BULLETIN

DATE	3-5-84
------	--------

FIREFOX

Amplifone Raster Modification

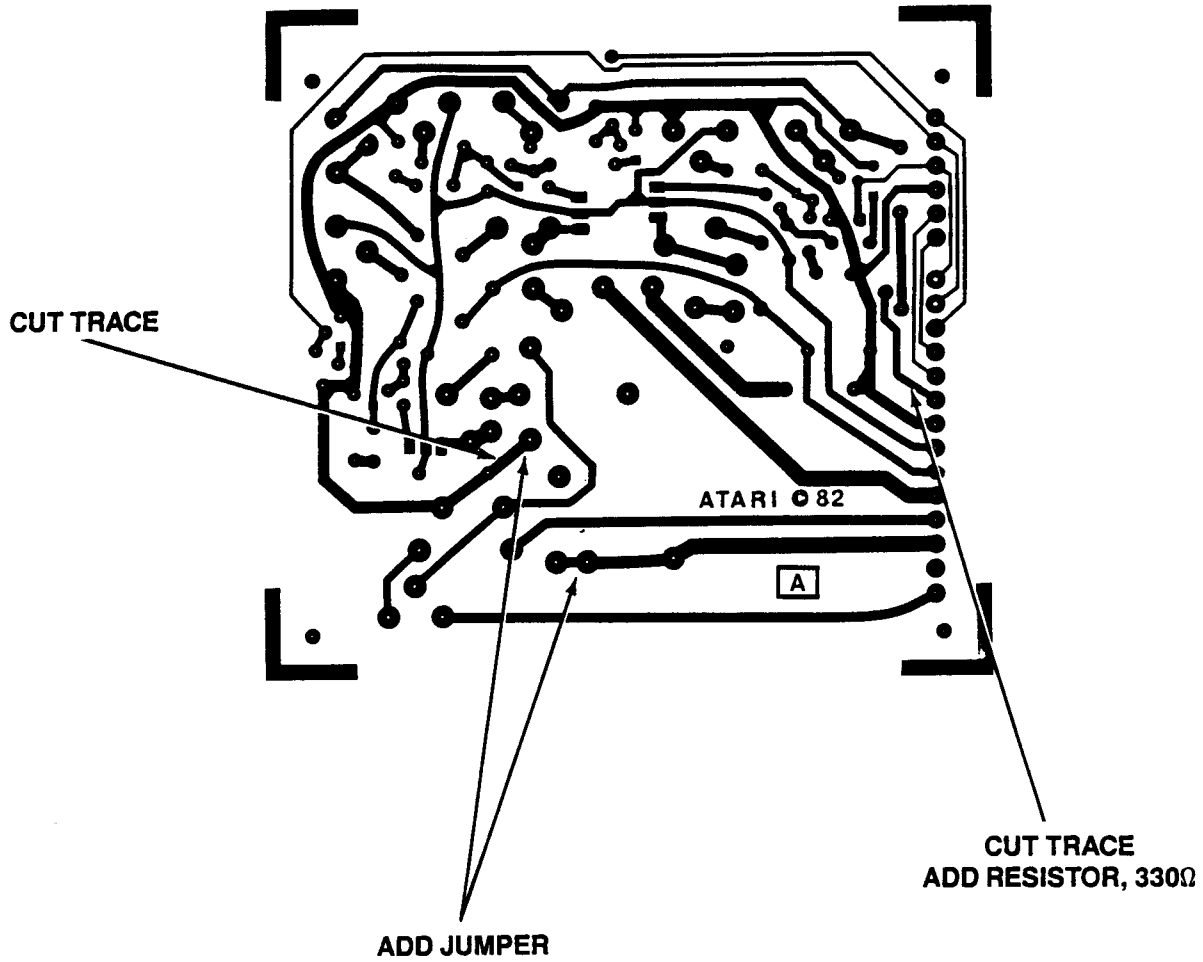
✓ **2.** Cut the trace between connector J8 pin 9 pad and the base pad of Q10. Install a 330 ohm, $\pm 5\%$, $\frac{1}{4}$ watt, resistor between the base of Q10 and the connector J8 pin 9 pad.

Neck PCB Assembly

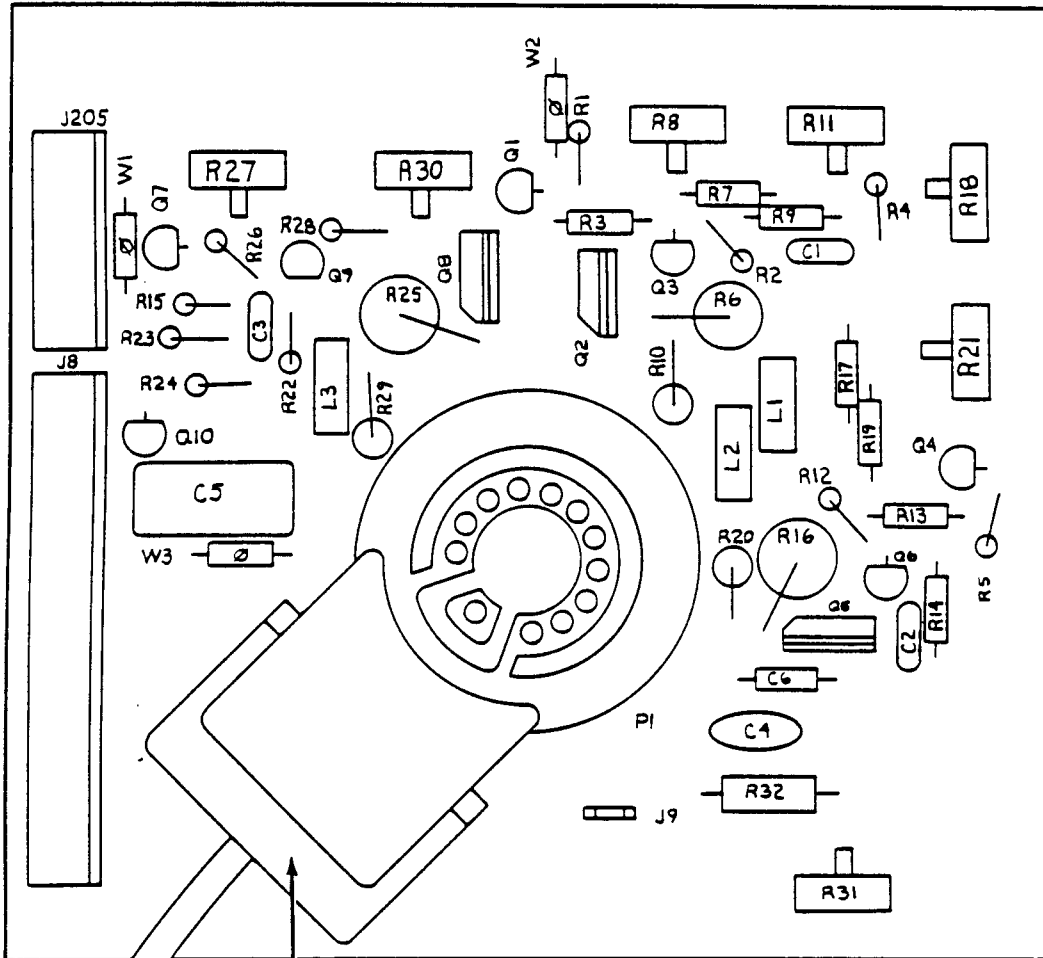
✓ **1. Neck Board**

Cut the trace between the pad at CRT socket pin 5 and the nearest pad. Install an insulated jumper (1000 volts or better insulation) between pad at CRT socket pin 5 and either of the pads at spade lug J9. Use a number 20 wire.

3. Remove the focus terminal cover from the CRT socket and unsolder the focus lead from the terminal. Solder a 22 meg-ohm, $\pm 5\%$, $\frac{1}{2}$ watt carbon-composition resistor to the terminal with the end flush with the terminal and resistor parallel to the board. Solder the focus lead flush with the other end of the resistor, and trim the resistor lead. Route the focus lead back to the exit groove, and replace the cover.

4. Deflection Board

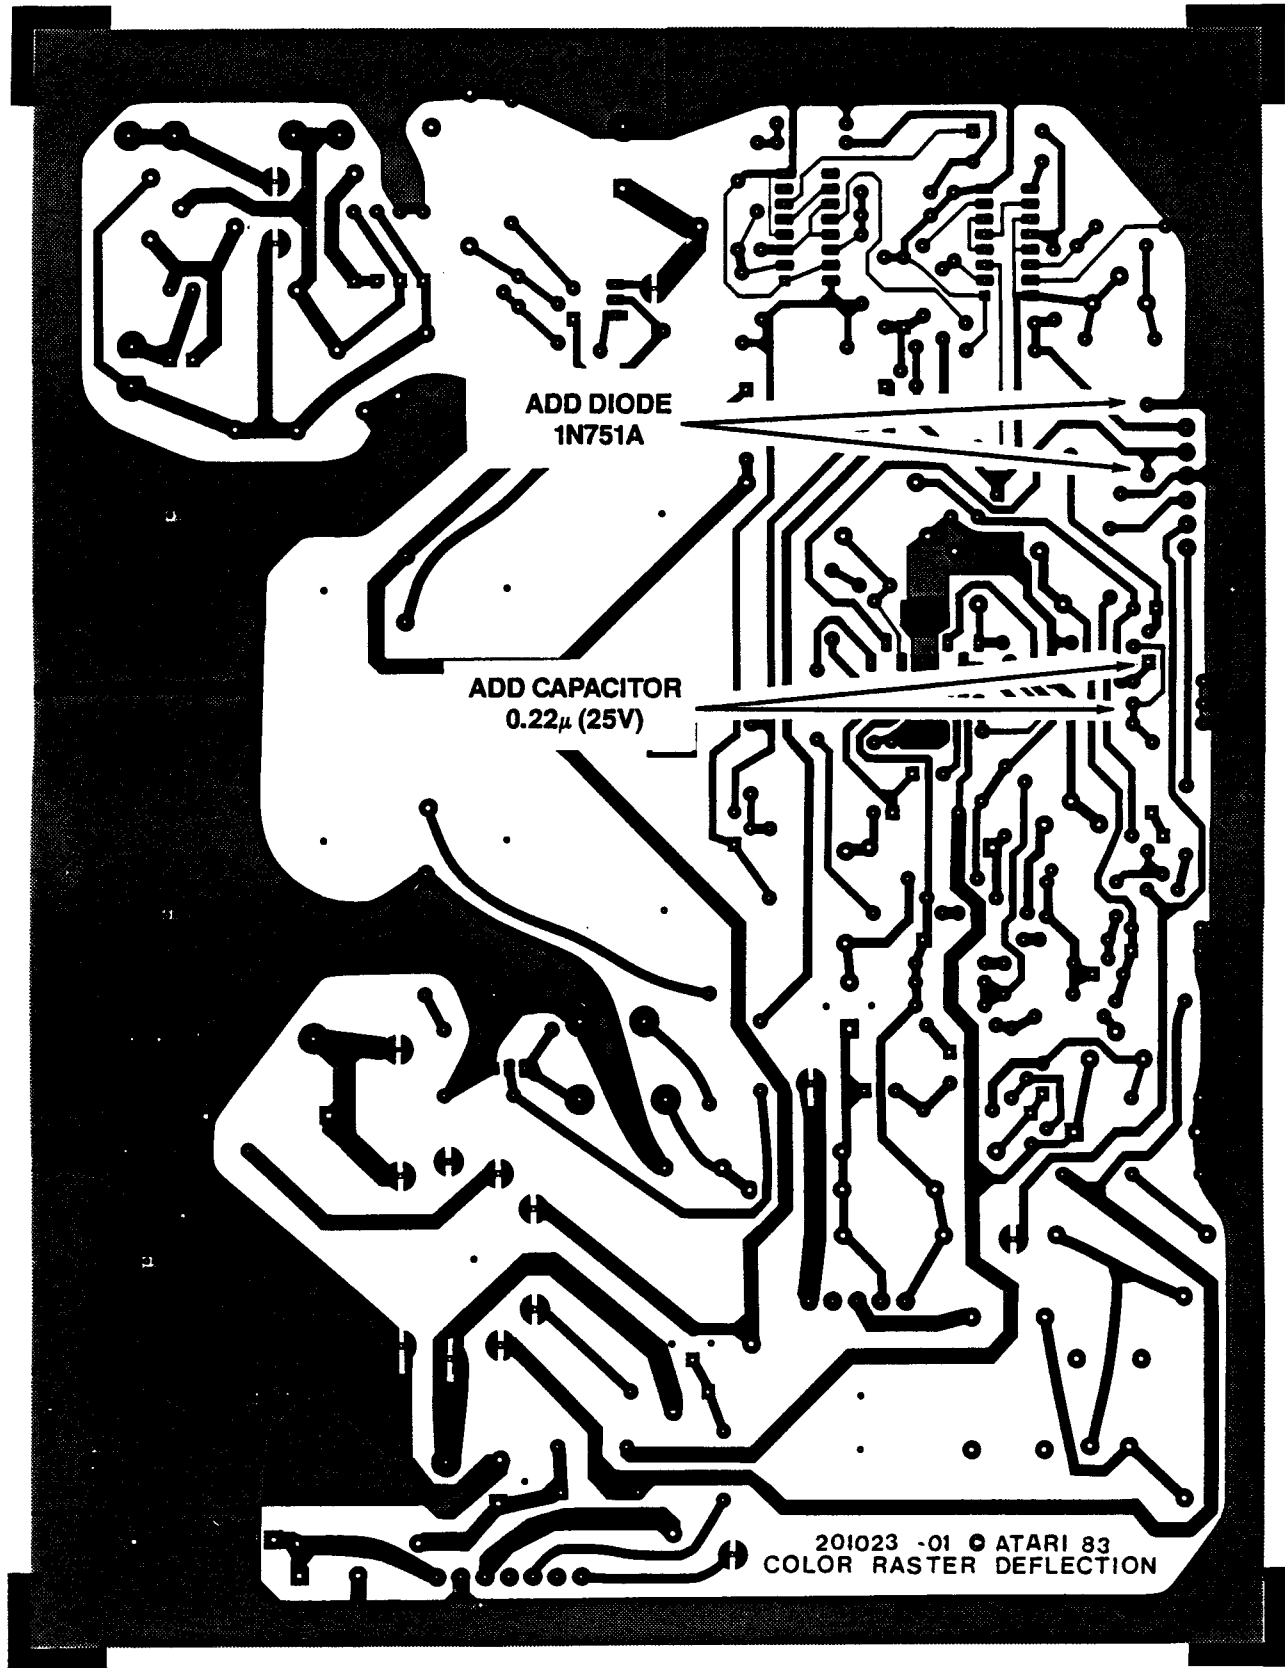
Install a 1N751A zener diode (5.1 V) to the vertical sync input, anode to ground, as follows:

- a. Locate the first pad connected to J1 pin 5 on the trace or circuit side of the board. Note: PLL board is installed in place of J1.
- b. Locate the pad going to ground near J1 pin 6, between pin 6 and R10.
- c. Install the zener diode (anode to ground) between these two pads on the circuit side of the PCB.

- 5.**
 - a. Remove C5 (0.1 μ F) axial cap.
 - b. Install a 0.22 μ F (25 V) axial cap between the cathode and gate of Q4 (MCR101), soldering one lead of the cap to the cathode pad (square pad) of Q4 and the other lead to the pad of C5 connected to the gate of Q4. Install the cap on the circuit side of the PCB.
